REGULATION No. 46 (Devices for indirect vision)

**Report of the informal group on camera monitor systems.**

Annex 1

## Annex 2

**Figure A** Diagram of the blooming measurement set-up. 1: Black & white test pattern. 2: Lamps to make the test pattern evenly illuminated. 3: Mirror. 4: High intensity light. 5: Camera. 6: Monitor.

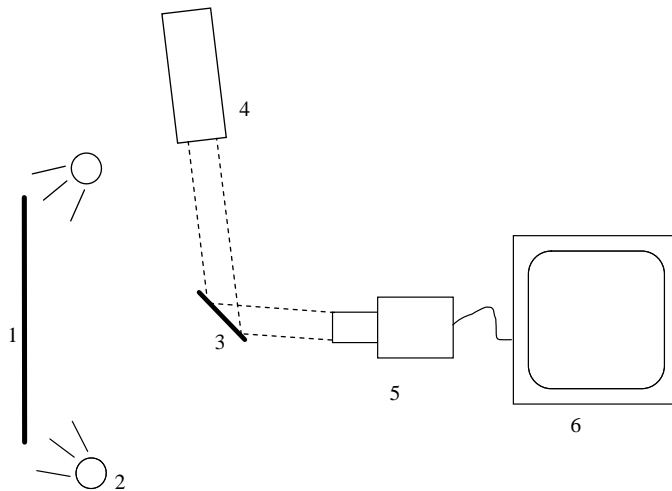
**6.2.2.2.1.4. An example of the set-up is given in the figure A below.**

**6.2.2.2.1. The camera shall function well in conditions in which sunlight falls on the camera. The saturated area, defined as the area in which the luminance contrast ratio ( $C=L_w/L_b$ ) of a high contrast pattern falls below 2.0, shall not cover more than 15 % of the displayed image under the conditions of paragraph 6.2.2.2.1.1 to 6.2.2.2.1.4.**

**6.2.2.2.1.1. A black and white test pattern, having a minimum contrast ratio of 20 shall be positioned in front of the camera.  
The test pattern shall be evenly illuminated at an illumination of  $3000 \pm 300$  Lx.**

**6.2.2.2.1.2. The camera shall be hit by a (simulated sun) light of 40 kLx, spanning an angle between 0.6 and 0.9 degrees with an elevation angle of 10 degrees (directly or indirectly via a mirror) removed from the optical axis of the sensor.**

- have a spectrum D65 with a tolerance of  $\pm 1500$ K,
  - be homogene in space and time within a tolerance of 2 kLx
- [The emission of the light source in the infrared shall be negligible.]**

**6.2.2.2.1.3. There shall be no ambient illumination of the monitor during the test.**

Figure 4: ~~Class I field~~ **Field of vision of Class I mirror**

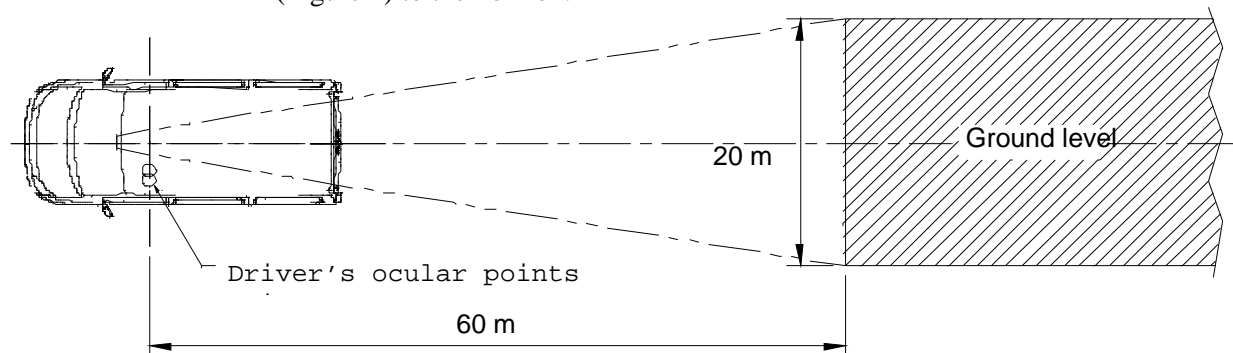
Justification: Alignment of the text with the new definition of classes (para. 2.4).

5.2.4.1. ~~Interior rear view mirror~~ **Central rear-view field of vision (Class I)**

The field of vision must be such that the driver can see at least a 20 m wide, flat, horizontal portion of the road centred on the vertical longitudinal median plane of the vehicle and extending from 60 m behind the driver's ocular points (Figure 4) to the horizon.

**Figure 7: Field of vision of Class IV wide-angle mirrors**  
~~Class IV wide-angle field of vision~~

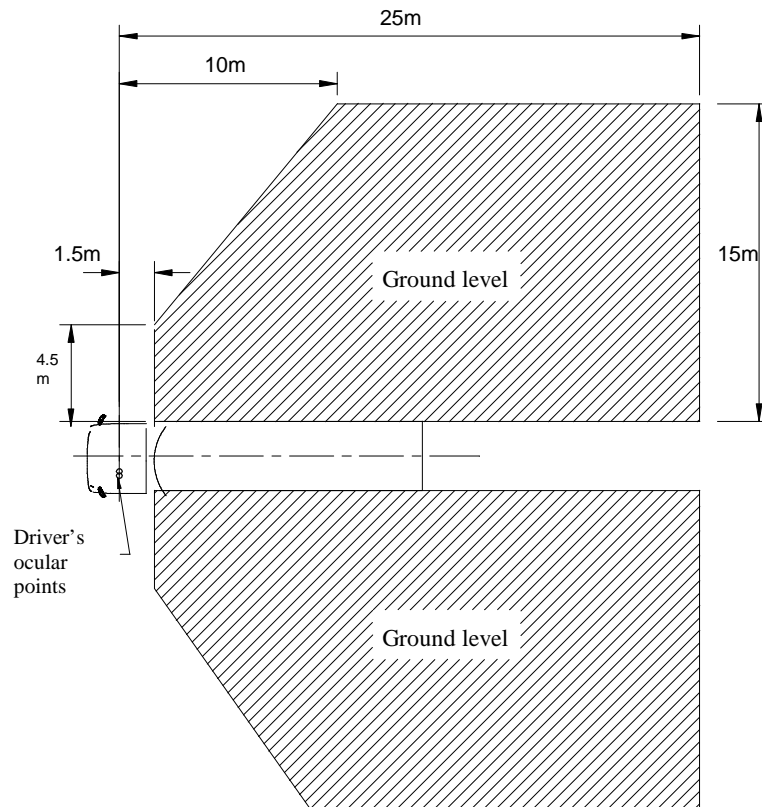
**Justification:** Alignment of the text with the new definition of classes (para. 2.4); figure 7 has been corrected on the passenger's side so that the indicated dimensions are in correspondence with the front of the grey area.

In addition, the road must be visible to the driver over a width of 4.5 m, which is bounded by a plane parallel to the median longitudinal vertical plane and passing through the outermost point of the vehicle starting from a point 1.5 m behind the vertical plane passing through the driver's ocular points (see Figure 7).

In addition, the road must be visible to the driver over a width of 4.5 m, which is bounded by a plane parallel to the median longitudinal vertical plane and passing through the outermost point of the vehicle starting from a point 1.5 m behind the vertical plane passing through the driver's ocular points (see Figure 7).

15.2.4.5. ~~Close proximity" exterior mirror (Class V)~~ **Class V close-proximity fields of vision**

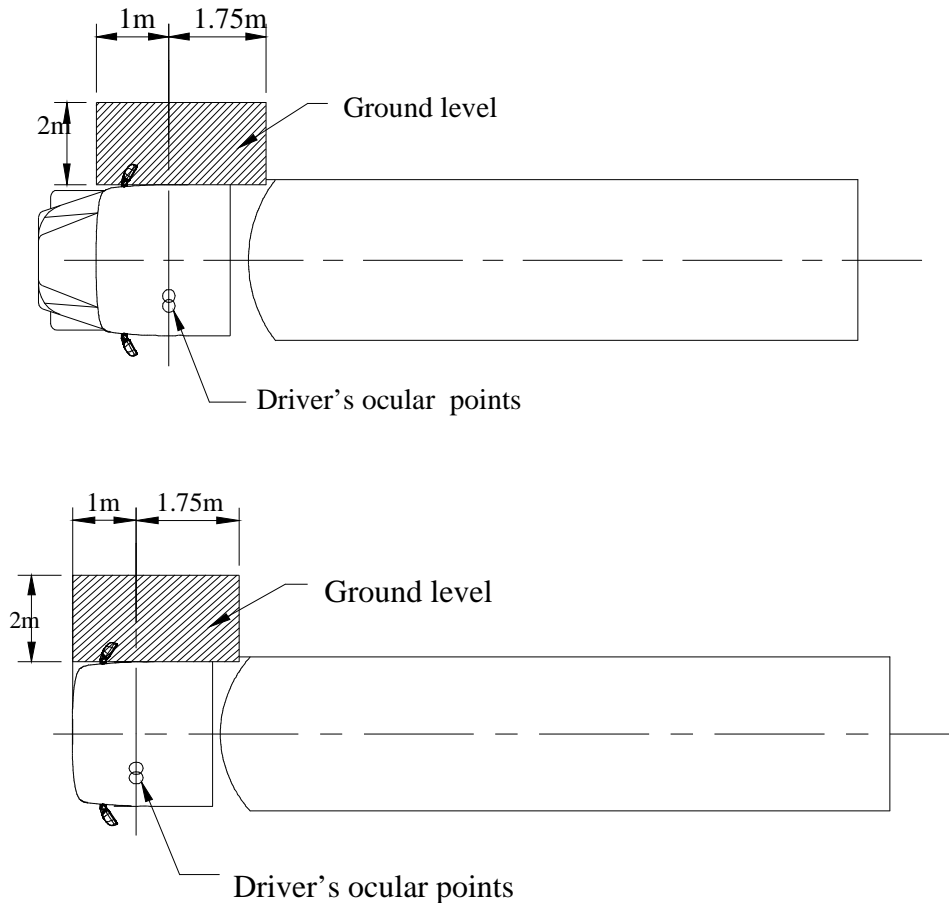
38. Paragraph 15.2.4.5. amend to read:

The field of vision must be such that the driver can see a flat horizontal portion of the road along the side of the vehicle, bounded by the following vertical planes (see Figures 8a and 8b):

Figure 10: ~~Field of vision of Class VII~~ **field of vision mirrors**.

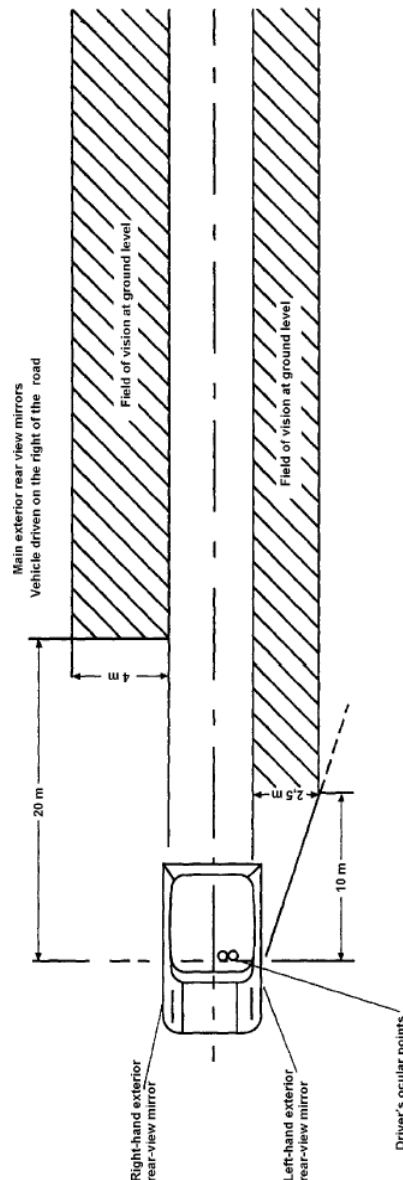
Justification: Alignment of the text with the new definition of classes (para. 2.4).

the vehicle on the driver's side of the vehicle and extends from 10 m behind the driver's ocular points to the horizon (see Figure 10).

15.2.4.7.2. ~~Exterior~~ **Main rear-view field of vision mirror** on the passenger's side

The field of vision must be such that the driver can see at least a 4 m wide flat, horizontal portion of the road which is bounded by a plane parallel to the median longitudinal vertical plane passing through the outermost point of the vehicle on the passenger's side and which extends from 20 m behind the driver's ocular points to the horizon (see Figure 10).
